SUBJECT: SAN ONOFRE NUCLEAR GENERATING STATION, UNITS 2 AND 3 – RELIEF REQUEST ISI-3-30, REQUEST FOR RELIEF FROM INSERVICE INSPECTION REQUIREMENTS FOR REACTOR VESSEL HEAD IN-CORE INSTRUMENT NOZZLES (TAC NOS. ME2340 AND ME2341)

SAFETY EVALUATION BY THE OFFICE OF NUCLEAR REACTOR REGULATION
THIRD 10-YEAR INSERVICE INSPECTION INTERVAL RELIEF REQUEST ISI-3-30,
INSPECTION OF REACTOR VESSEL HEAD IN-CORE INSTRUMENT NOZZLES
SAN ONOFRE NUCLEAR GENERATING STATION, UNITS 2 AND 3
SOUTHERN CALIFORNIA EDISON COMPANY
DOCKET NOS. 50-361 AND 50-362

FIG. 2 EXAMINATION VOLUME FOR NOZZLE BASE METAL AND EXAMINATION AREA FOR WELD AND NOZZLE BASE METAL

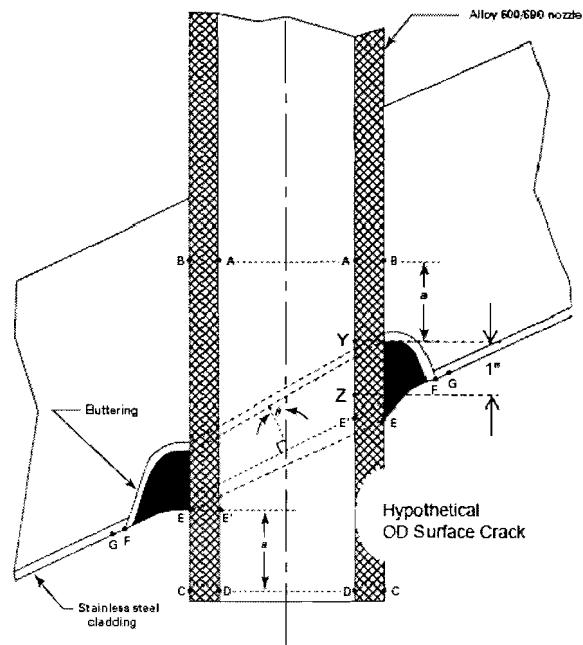
Figure 2 identifies the required volume of nozzle tube to be inspected as a distance "a" above the highest point of the root (Y) of the J-groove weld to a distance "a" below the lowest point of the toe (E) of the J-groove weld. The distance "a" is equal to 1.5 inches (38 millimeters (mm)) for incidence angle, Θ , ≤ 30 degrees and for all nozzles ≥ 4.5 inches (115 mm) outside diameter (OD) or 1 inch (25 mm) for incidence angle, Θ , ≥ 30 degrees; or to the end of the nozzle tube, whichever is less. Since the ICI nozzle tubes have an OD of 5.563 inches, the required distance "a" is 1.5 inches. If a surface examination is being substituted for a volumetric examination on a portion of a penetrating nozzle tube that is below the toe of the J-groove weld, the surface examination shall be of the inside and outside wetted surface of the penetration nozzle tube not examined volumetrically (A-D-C-E).

The licensee proposes to perform an eddy current (ET) examination of the nozzle tube ID (A-D) and bottom surfaces (C-D). The ET examination will extend from a distance "a" above the

highest point of the J-groove weld root (Y) to the extent possible below the J-groove weld. Instead of the ET examination of the nozzle tube OD surface (C-E), the licensee proposes to perform a volumetric examination of the nozzle tube on the ID surface from a distance "a" above the highest point of the J-groove weld root to the extent possible below the J-groove weld (A-D) using time-of-flight diffraction (TOFD) UT examination. Where the UT data quality between the J-groove weld root to 1 inch below the J-groove weld root (Y-Z) are determined to be unacceptable, a compensatory ET examination of the corresponding ICI nozzle tube OD surface will be performed. The compensatory ET examination of the OD surface will include approximately ¼ inch of the outside nozzle tube surface adjacent to the lower extent of the J-groove weld fillet.

As an alternative to the examination required by 10 CFR 50.55a(g)(6)(ii)(D)(3), the licensee has proposed using ET to examine the ICI nozzle tube ID surface from the required distance "a," per Code Case N-729-1, above the highest point of the root of the J-groove weld to the maximum extent possible below the J-groove weld, including the bottom-end surface of the nozzle. However, instead of performing an ET examination of the nozzle tube OD surface below the J-groove weld toe, the licensee proposes to perform a supplemental UT examination of the nozzle tube ID surface from a distance "a" above the root of the J-groove weld to the extent possible below the J-groove weld using personnel and procedures which were Electric Power Research Institute (EPRI)-qualified to perform UT examinations on control element drive mechanism (CEDM) nozzles. The NRC staff notes that such UT examination has been used previously to satisfy the requirements of the First Revised NRC Order EA-03-009 (Order (Reference 4).

The NRC staff notes that axial through-wall cracks and axial ID surface cracks do not need to be considered in the flaw growth analysis since the Code-compliant ET examination of the nozzle tube ID surface (A-D) will ensure that no surface penetrating cracks exceeding Code limits exist on the ID surface. Also, OD surface cracks above the J-groove weld toe do not need to be considered in the flaw growth analysis since they cannot be initiated in the absence of primary water, and the existence of primary water in the OD surface region above the J-groove weld is evaluated by the required bare metal visual inspection of the head and the qualified weld leak path assessment.

The bounding condition for a hypothetical crack that is in contact with primary water and is not examined by a Code-compliant procedure is a surface crack below the J-groove weld on the nozzle tube OD surface whose crack depth (a) approaches the wall thickness (t) at the time of the ET ID surface examination (i.e., a/t approaches unity). The uppermost extent that such a hypothetical crack on the nozzle tube surface could exist is determined by the TOFD UT examination from the nozzle tube ID surface. The licensee's requirement of a minimum of 1 inch of acceptable UT data quality below the weld root ensures that a crack cannot exist in this volume. The NRC staff notes that, although the UT examination is not compliant with the requirements of 10 CFR 50.55a(g)(6)(ii)(D)(4), the operators and procedures have been qualified for CEDM nozzle tube examinations, and UT examination has been accepted for ICI nozzle tube examination under the Order. Therefore, the staff concludes that the examination provides reasonable assurance that an OD surface flaw does not exist within the specified 1-inch distance below the weld root.

After an increment in operating time, such an OD surface crack would be expected to become a through-wall crack and begin propagating in the axial direction. The licensee has analyzed the time required for a through-wall crack whose upper tip is located 1 inch below the J-groove weld root (Z) to propagate to the weld root (Y). The NRC staff has evaluated the licensee's FM crack

growth data (Reference 5, Figures C-5 and C-6) and calculated the time necessary for through-wall axial cracks on both the downhill and uphill sides of the ICI nozzle tube to propagate to the weld root. The staff determined that the minimum time required for such a through-wall axial flaw to propagate to the J-groove weld root is in excess of 2 years. Since this time is in excess of the length of an operating cycle at SONGS, the staff concludes that there is adequate margin to ensure the pressure boundary integrity for one cycle of operation.

ASME Code Case N-729-1, on which the examination requirements are based, allows justification of an alternative examination zone when it can be demonstrated, using the methodology in Appendix I of the Code Case, that a hypothetical axial crack in the unexamined zone below the J-groove weld in the nozzle tube will not grow to the toe of the J-groove weld prior to the next examination¹. For continuing long-term operation of the RPVH over several operating cycles, the possibility of corrosion of the steel RPVH must be avoided. Therefore, setting the acceptance criterion of axial crack propagation to the toe of the J-groove weld is both reasonable and conservative. The NRC staff has considered the proposed acceptance criterion that a hypothetical crack will not grow to the root, rather than to the toe, of the J-groove weld. The staff concludes that, when the RPVH will be replaced at the next refueling outage, as is the case for SONGS, Units 2 and 3, an appropriate acceptance criterion is to ensure the integrity of the pressure boundary for that one cycle. Thus, the staff concludes that crack propagation to the root of the J-groove weld is an appropriate evaluation criterion and accepts the licensee's analysis.

The NRC staff's evaluation and conclusions are based, in part, on the combination of ET coverage and on the extent of UT examination with acceptable data quality that was successfully achieved for the ICI nozzles in SONGS, Unit 2. Since such data are not yet available for examination of the ICI nozzles in SONGS, Unit 3, the staff stipulates that if the licensee cannot achieve at least 90 percent acceptable data quality coverage for the volume between the root of the J-groove weld and 2 inches below the J-groove weld root for SONGS, Unit 3, the licensee will need to submit a new relief request for Unit 3 which includes further justification for the extent of acceptable data quality coverage achieved.
